WASTEWATER COLLECTION SYSTEM

BASIS OF DESIGN REPORT

HONOR HEALTH

Re: Honor Health Medical Office Building Wastewater Collection System, Basis of Design Report Scottsdale, Arizona WP# 194976

WASTEWATER EXHIBIT

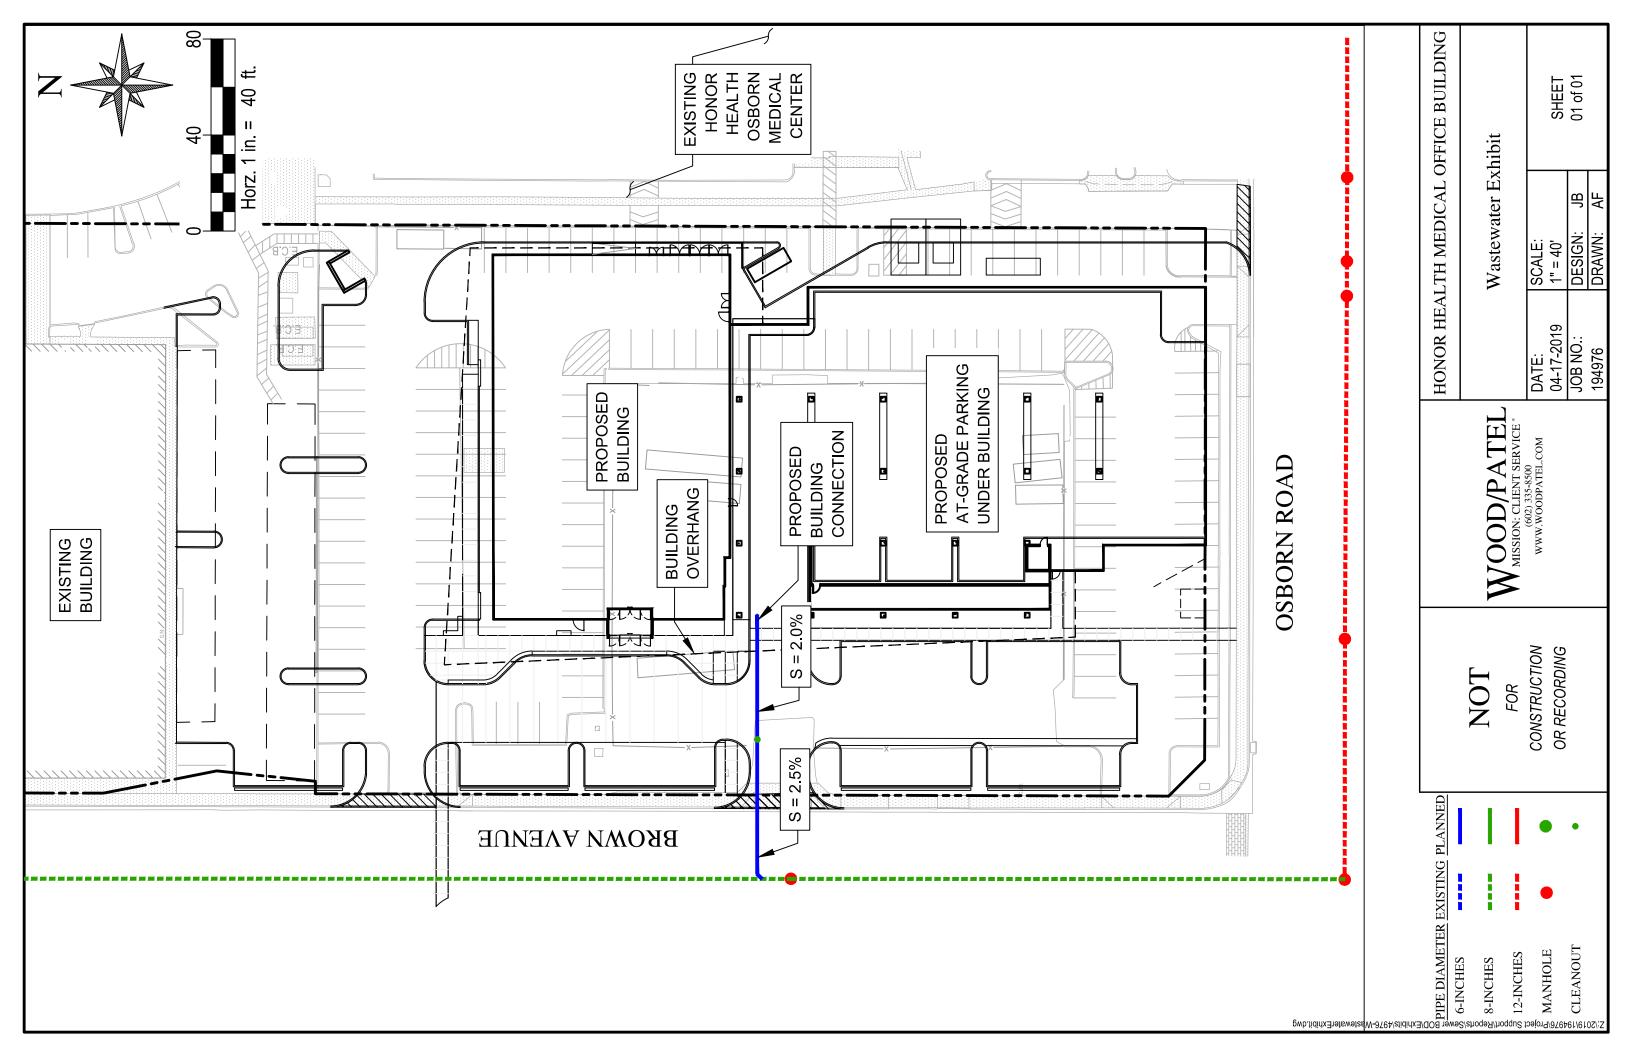
2) If sewer stub in southeast corner is not to be used it should be removed back to the main to make room for new parallel sewer in Osborn i.e. discharge onto Brown is likely preferred. Indicate stub removal on utility plan. 3) Address any applicable comments in email correspondence herein.

WATER EXHIBIT

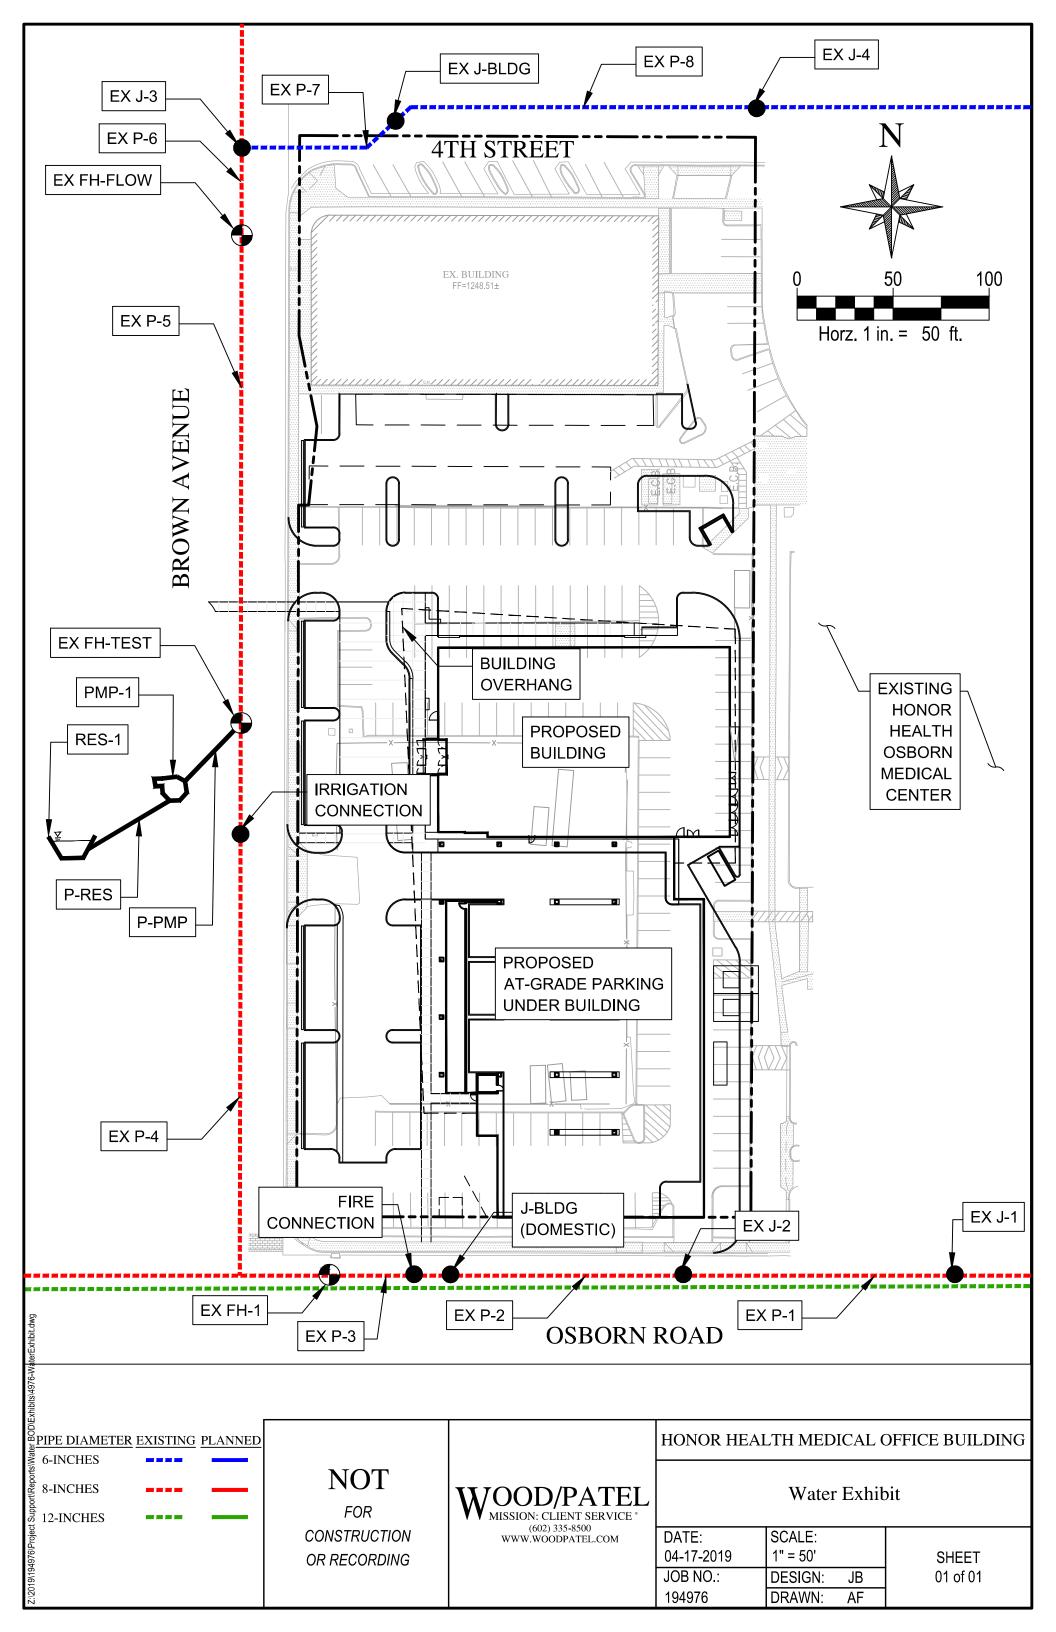
1) Evaluate using 8" water stub out located in southeast corner. This connects to a 12" main on Osborn. If not to be used (and not currently in use) remove stub back to main. Indicate on utility plan.

2) In final BOD show utility plan with meter and BFP. Provide meter and service line sizing per DS&PM and verify if meter vault is required.

3) Complete hydraulic analysis up to highest finished floor of building and show 15psi min concurrent with fire flow (associated with meter and service/supply line sizing)

4) Clarify required fire flow, both 1,250 and 1,500 are shown.

WATER EXHIBIT

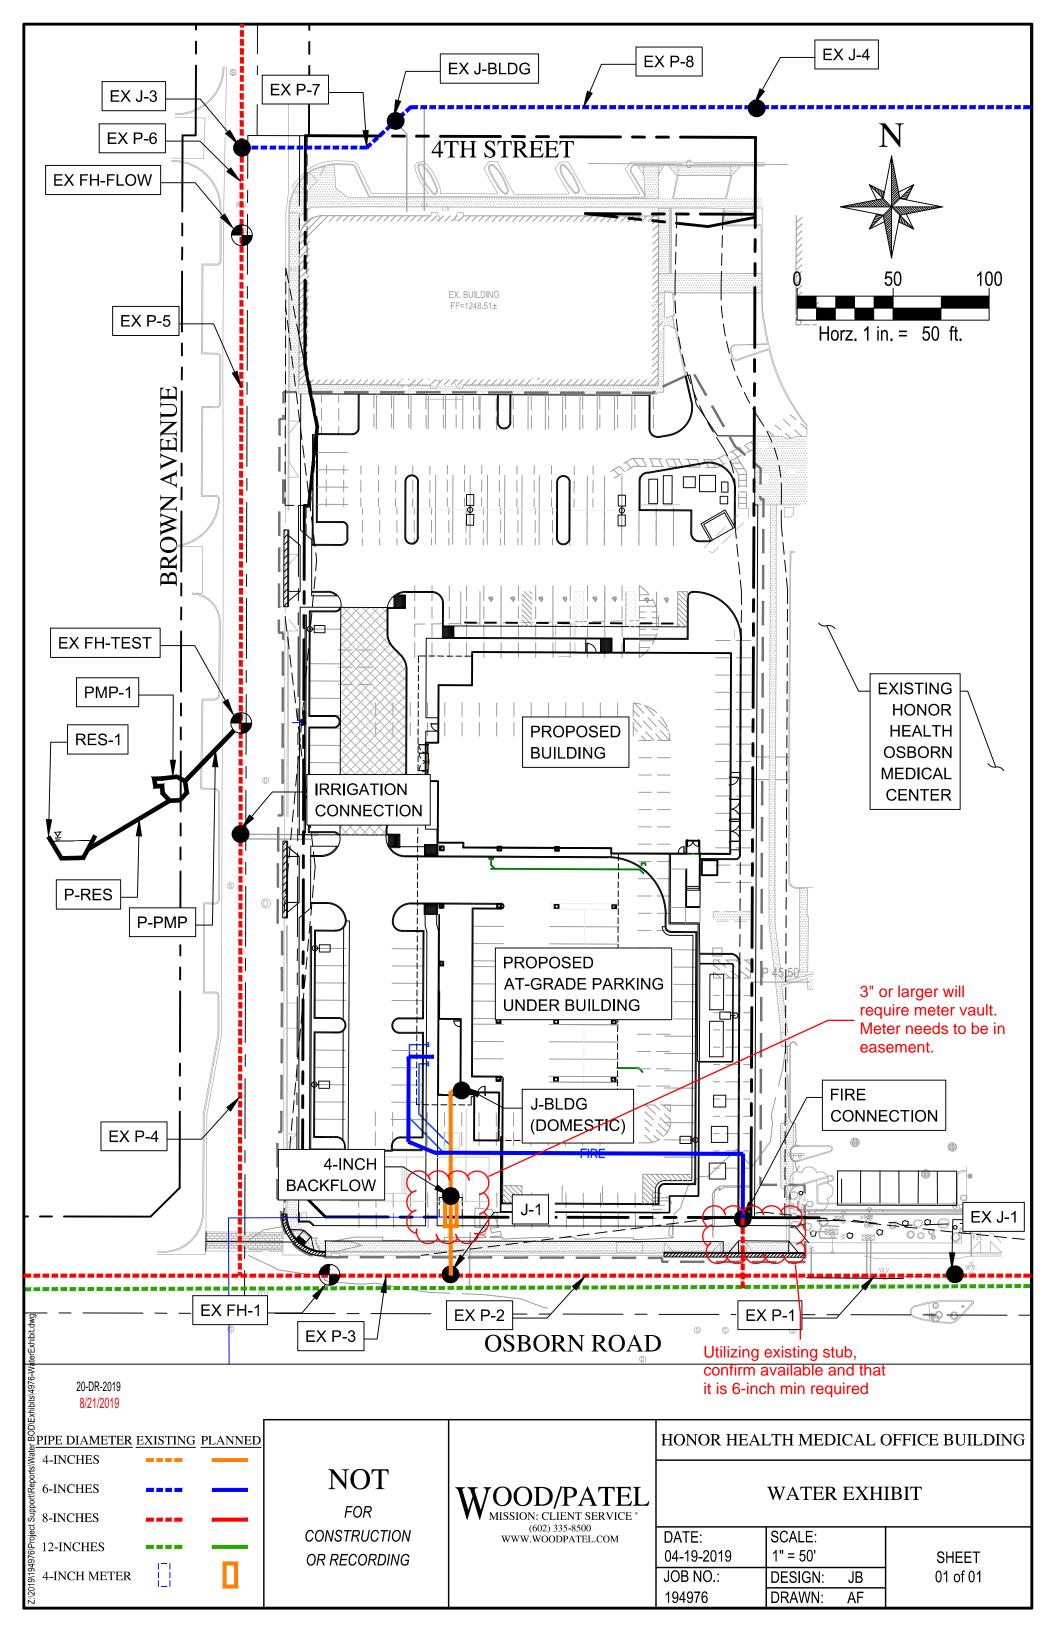
2) If meter is 3" or larger place in vault per COS detail 2345. 4-inch domestic meter proposed in text.
